**PSE&G** Public Service  
Electric and Gas  
Company

August 20, 1984

HOPE CREEK GENERATING STATION  
DOCKET NO. 50-354  
DRAFT SAFETY EVALUATION REPORT  
OPEN ITEM STATUS

Attachment 1 is a current list which provides a status of the open items identified in Section 1.7 of the Draft Safety Evaluation Report (SER). Items identified as "complete" are those for which PSE&G has provided responses and no confirmation of status has been received from the staff. We will consider these items closed unless notified otherwise. In order to permit timely resolution of items identified as "complete" which may not be resolved to the staff's satisfaction, please provide a specific description of the issue which remains to be resolved.

FIGURE 220.21-46  
 RESPONSE SPECTRA COMPARISON,  
 INTAKE STRUCTURE AT ELEV. 93'-0".  
 E-W. OBE, 2% DAMPING

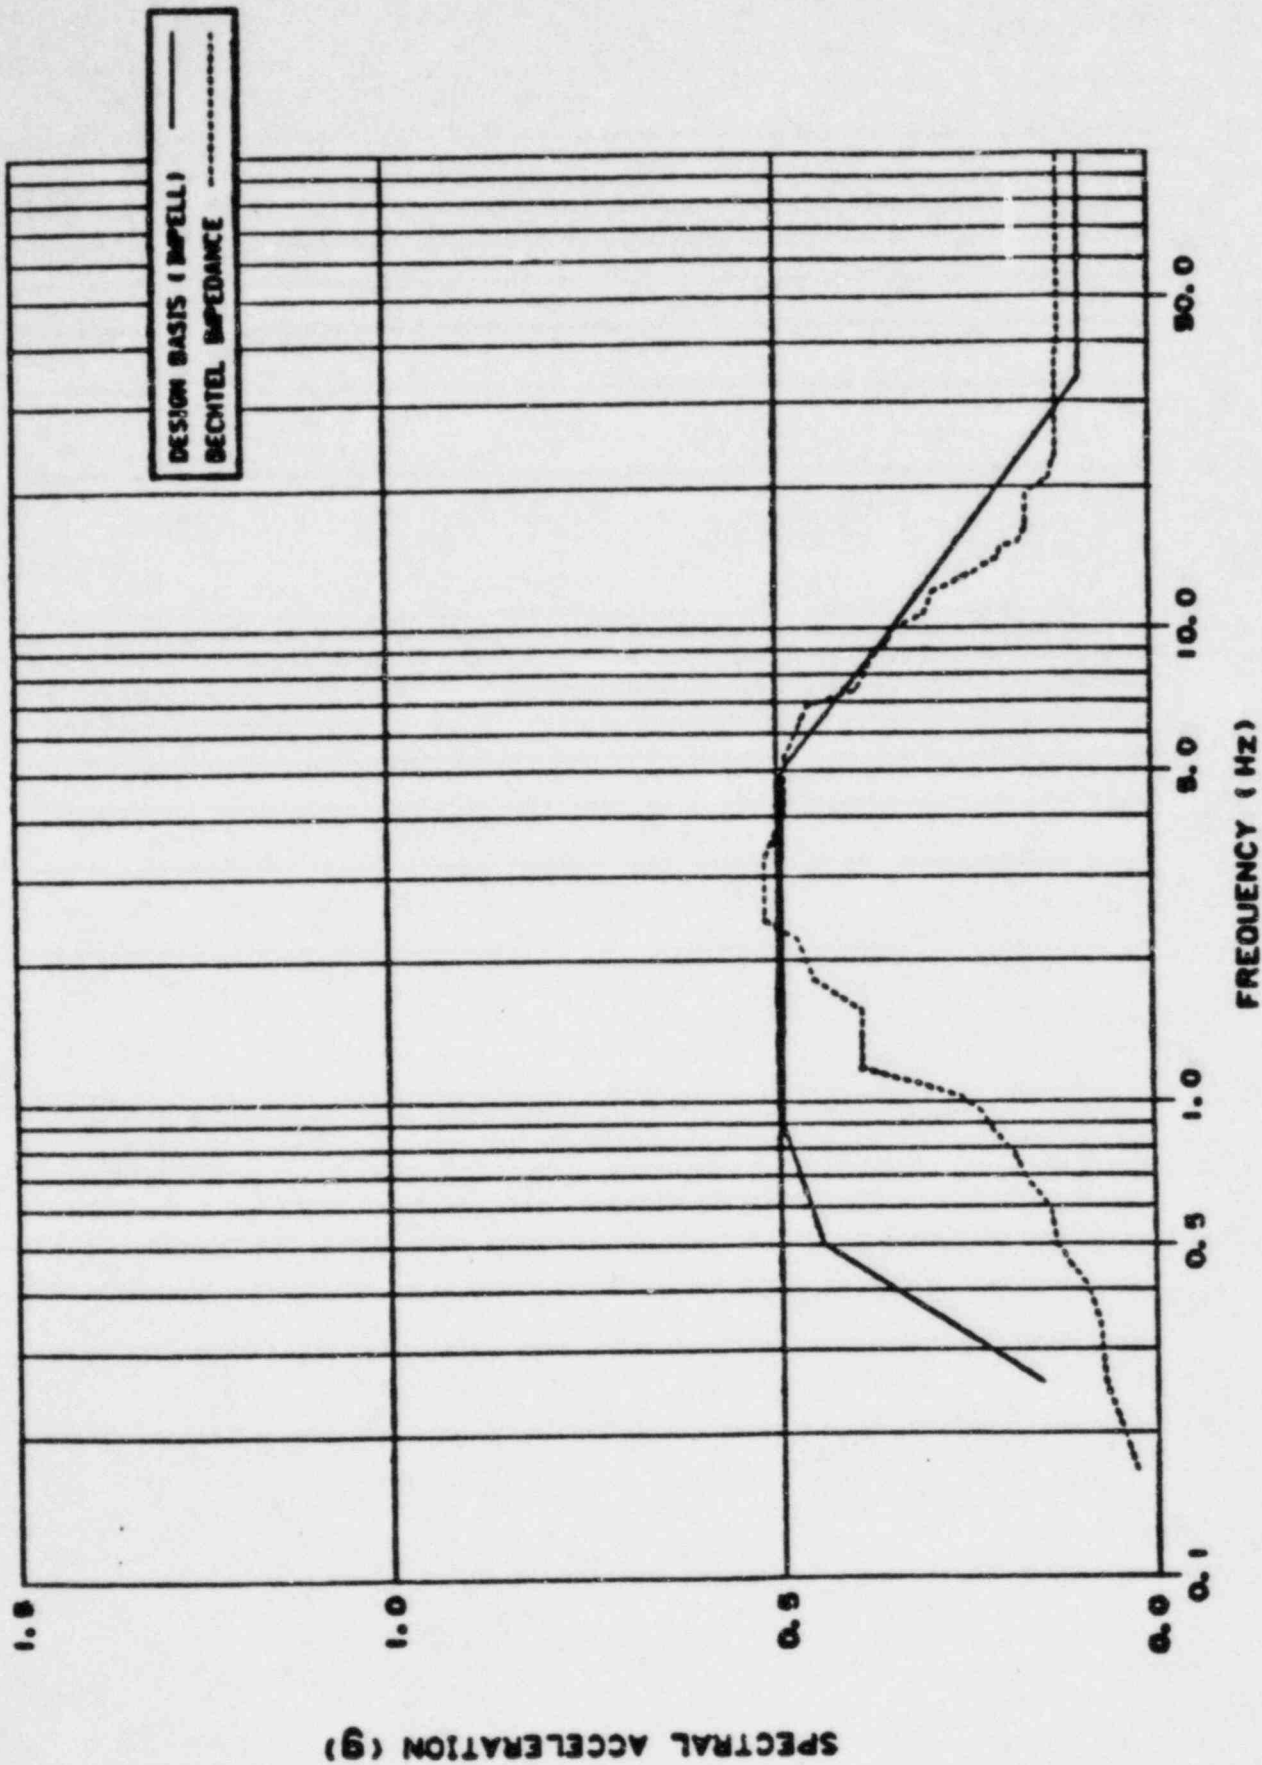
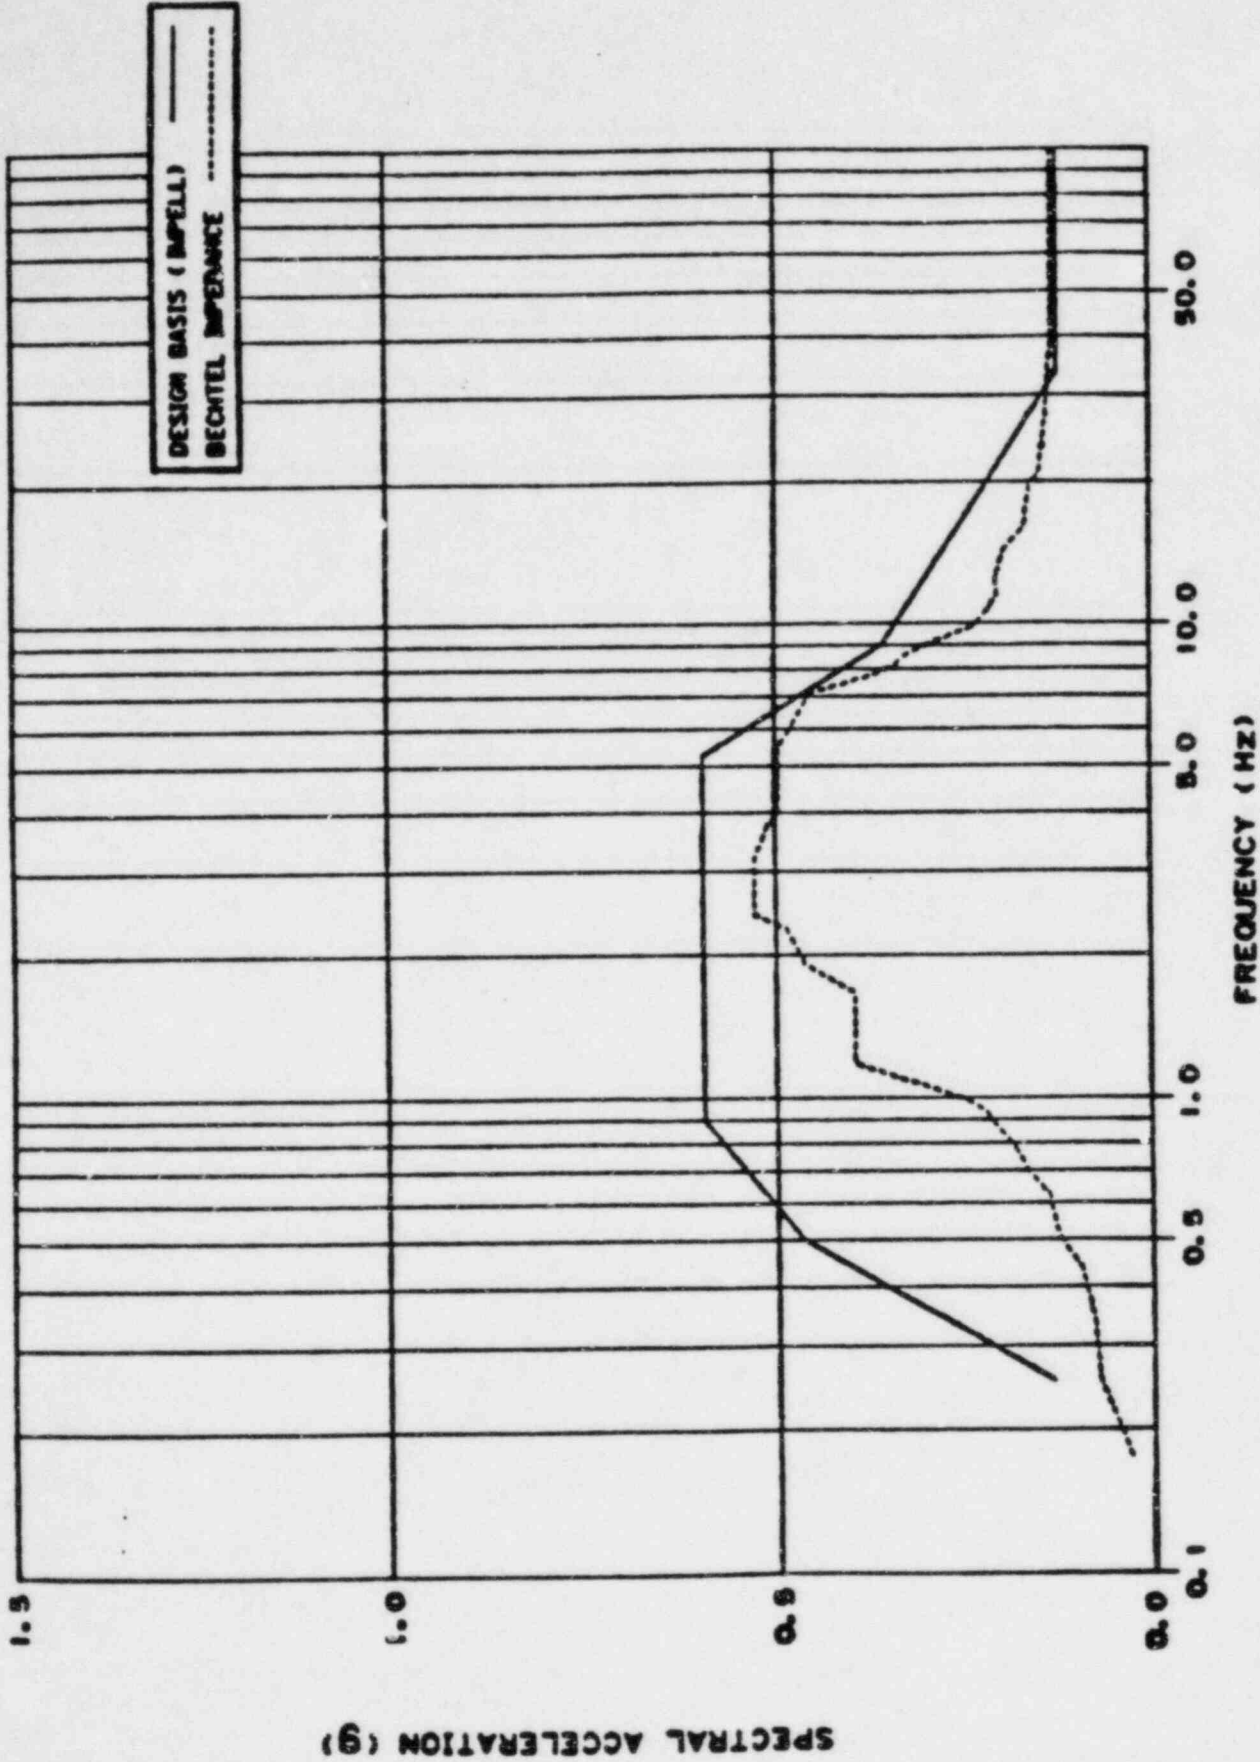
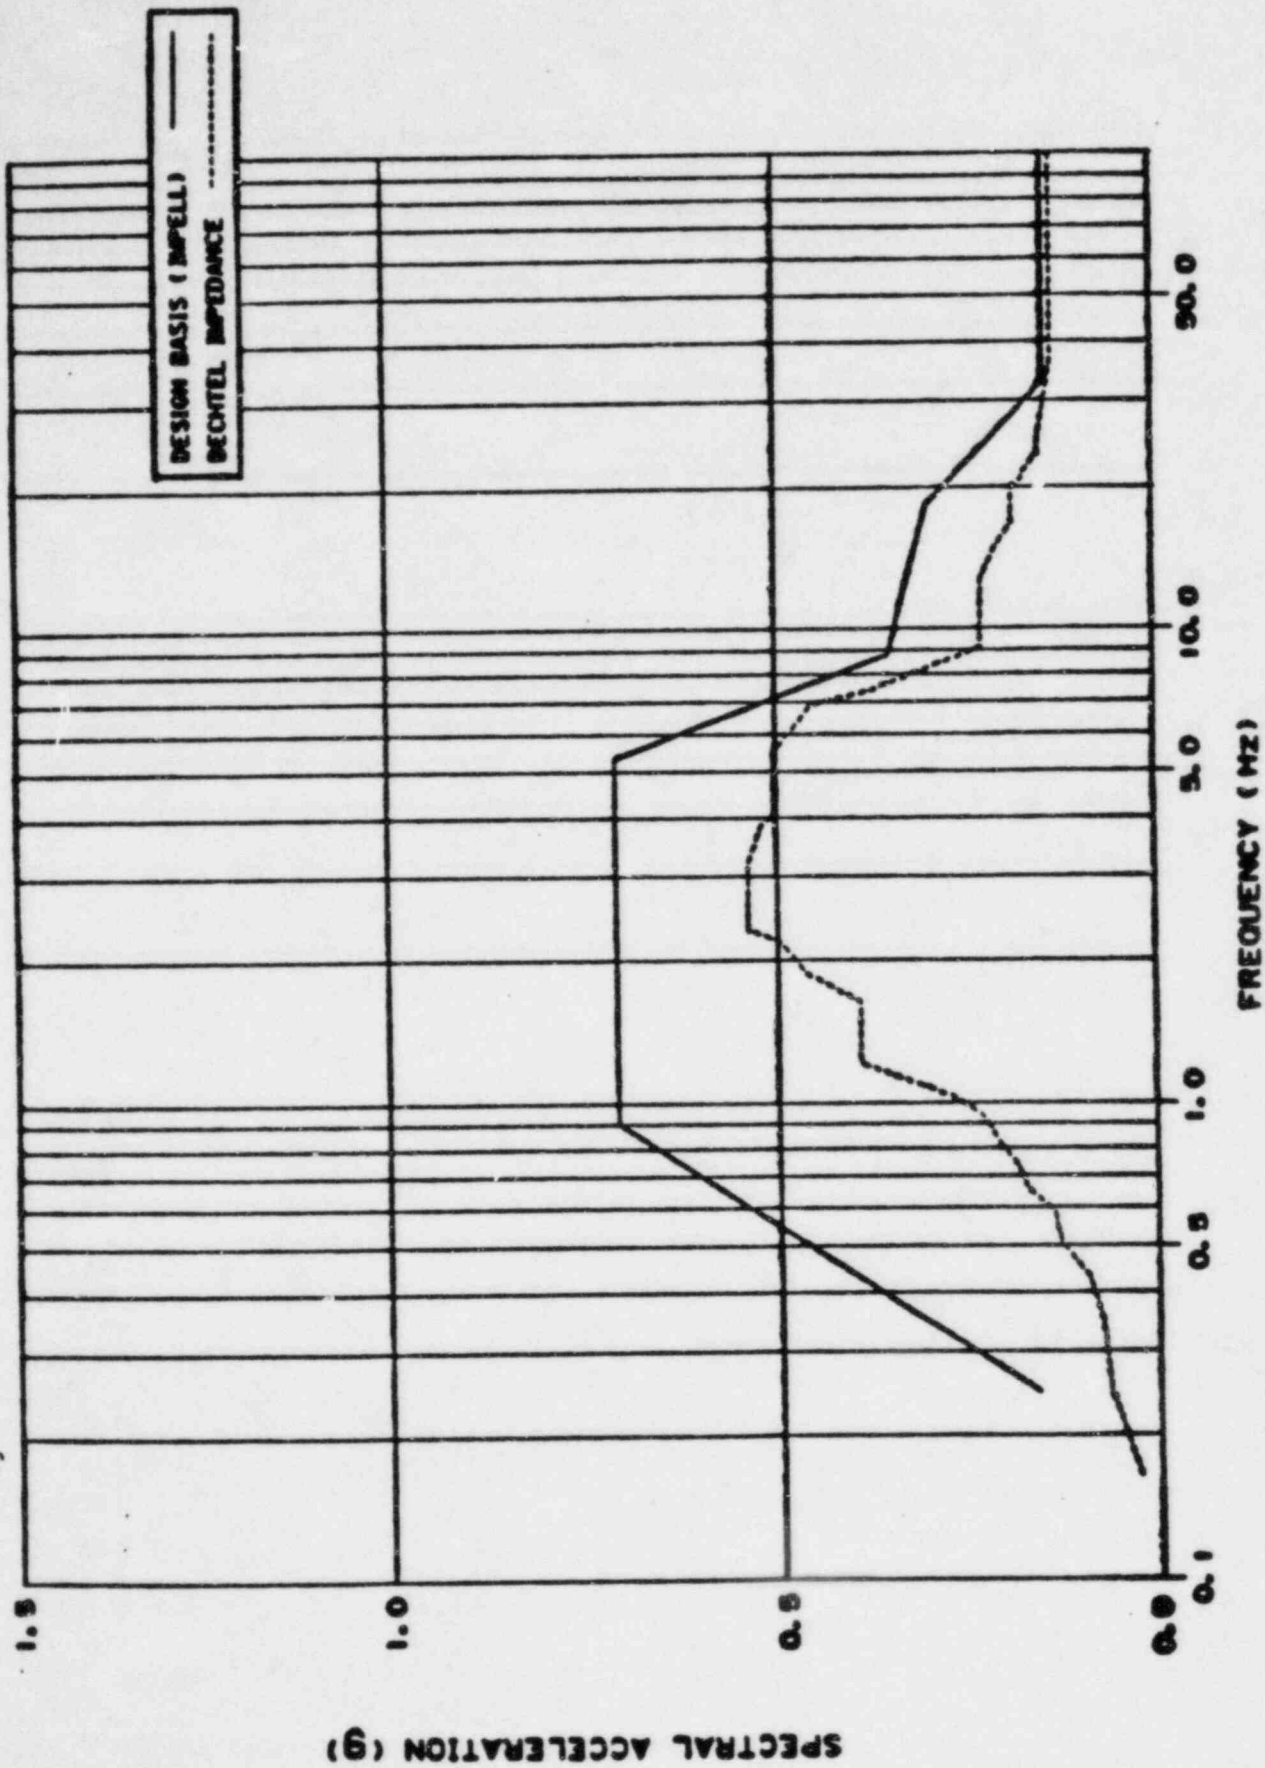
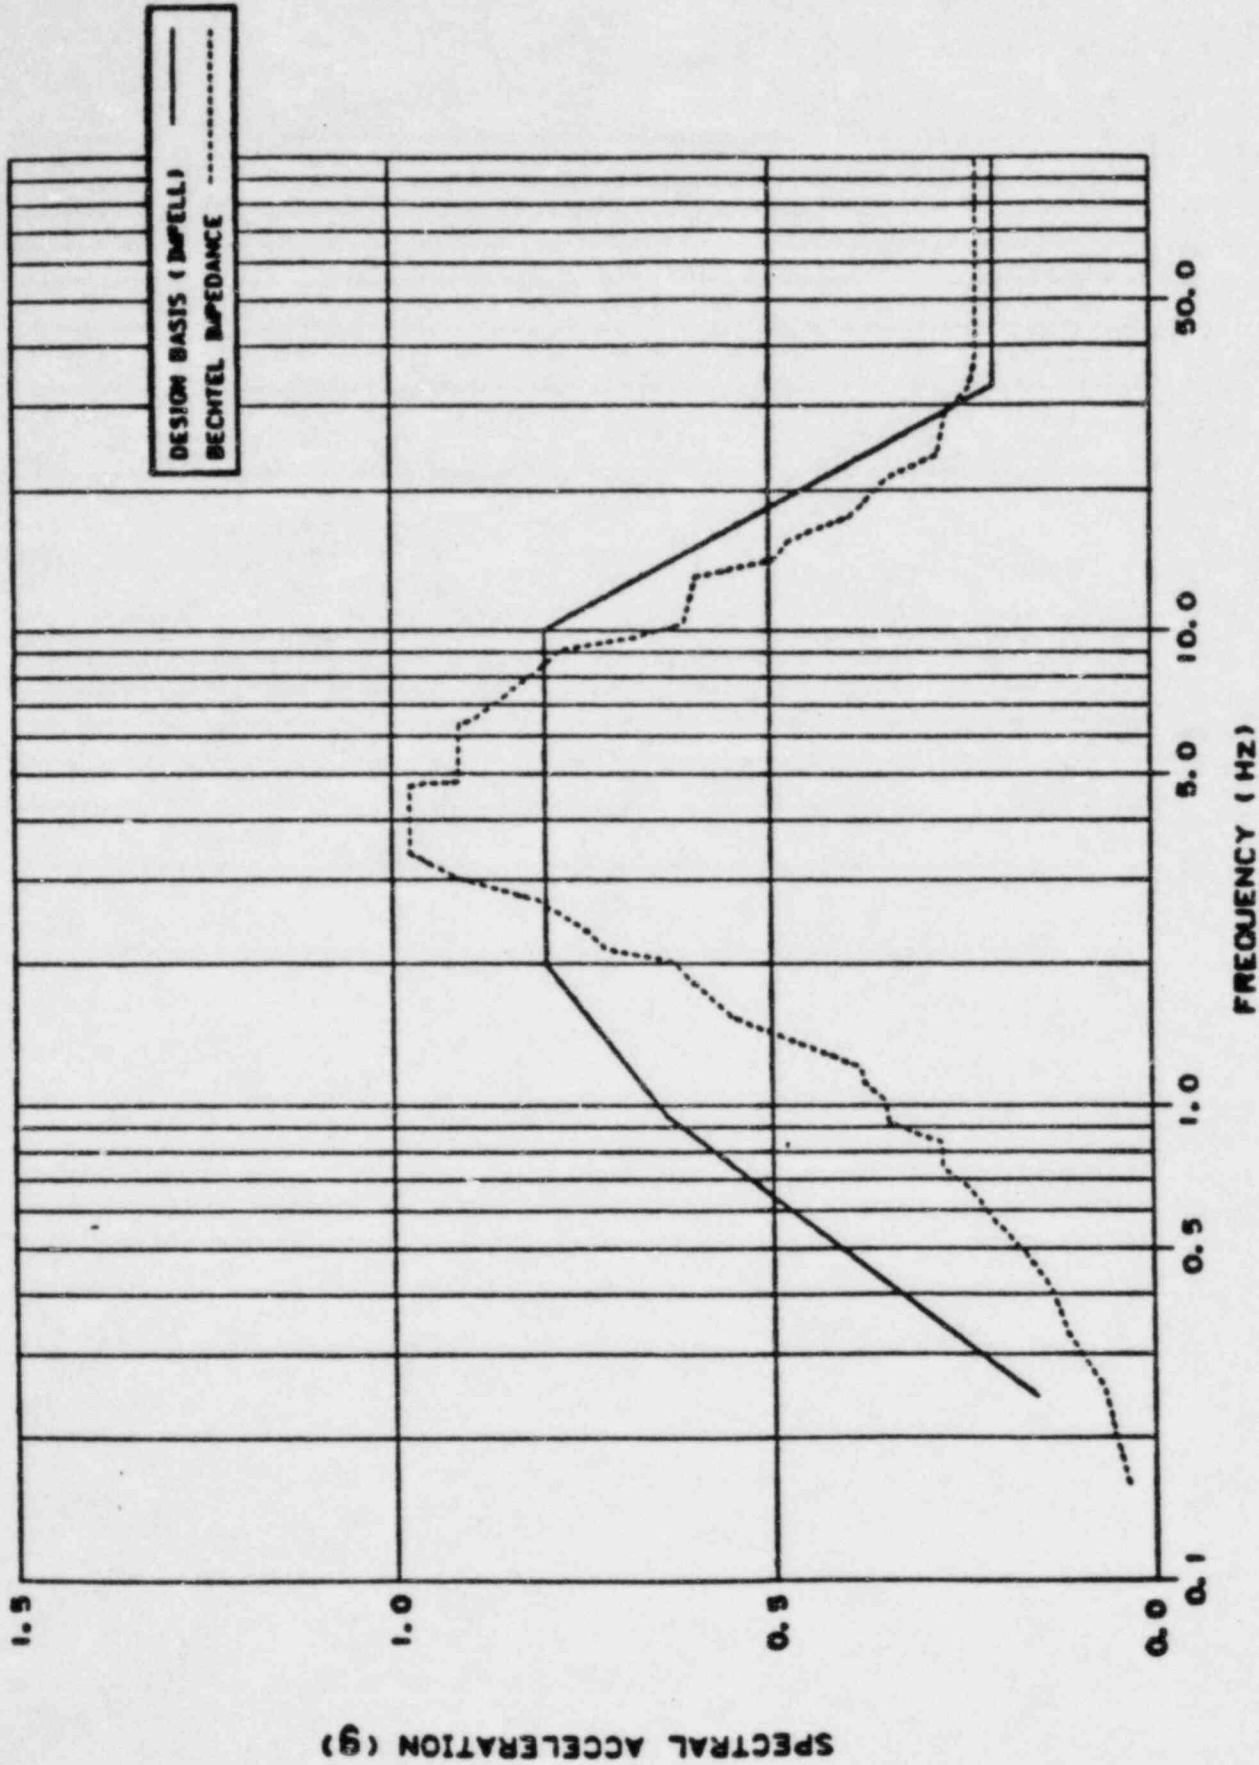
Figures 220.21-1 through 220.21-54 show a comparison of the 2 percent damping response spectra obtained from the design basis finite element and the impedance analyses for the reactor building, auxiliary building and the service water intake structure (SWIS).

¶ For the reactor and auxiliary buildings, the peak spectral accelerations obtained from the impedance analysis are generally lower than those obtained from the design basis analysis. However, the impedance analysis response spectra are not completely enveloped by those obtained from the design basis analysis, especially in the frequency range from 1.0 to 3.5 Hz. Also, there are some local exceedances in the higher frequency range, as shown in Figures 220.21-1 through 220.21-36. ¶ For the SWIS (Figures 220.21-37 through 220.21-54), the impedance analysis response spectra are generally enveloped by those obtained from the design basis analysis at elevation 114.0 feet. For other elevations, the impedance analysis spectral accelerations exceed the design basis spectral accelerations in some frequency ranges. These ranges vary approximately between 1.5 and 10.0 Hz.

In all cases, the items reviewed during these sampling studies can accommodate the loads resulting from the impedance analysis. Therefore, the impedance analysis results have no impact on the plant design.
